POD Change Description

Sigurd POD in product Datasheet prior transfer

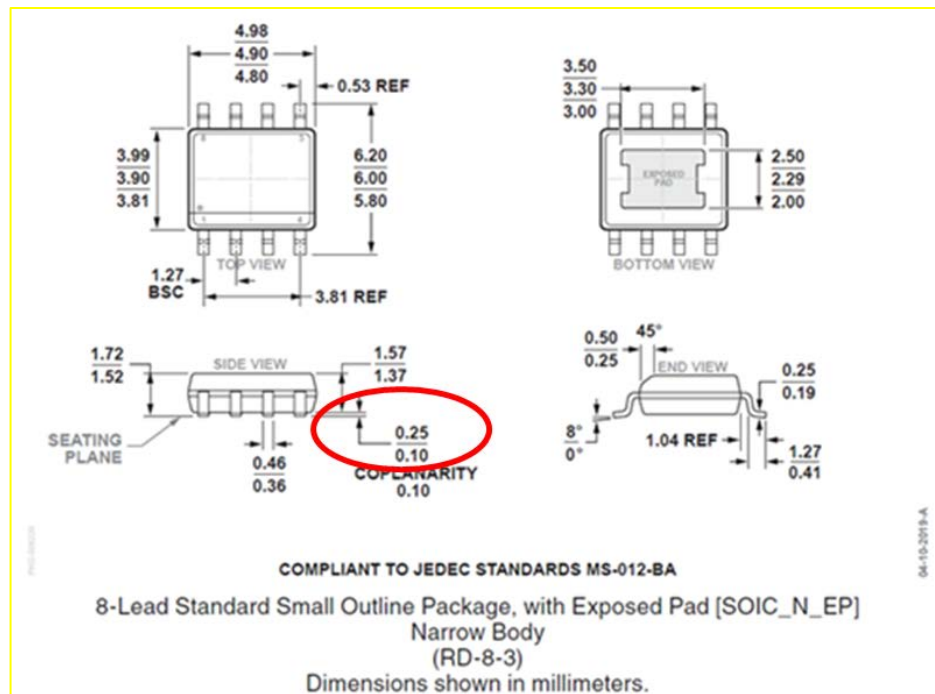
Assembly Site	Period	Stand-off Min (mils)	Stand-off Max (mils)
Sigurd	Prior Sept 2019	0	5
Carsem	Sept 2019 - present	4	10
Carsem	After PCN	0	5
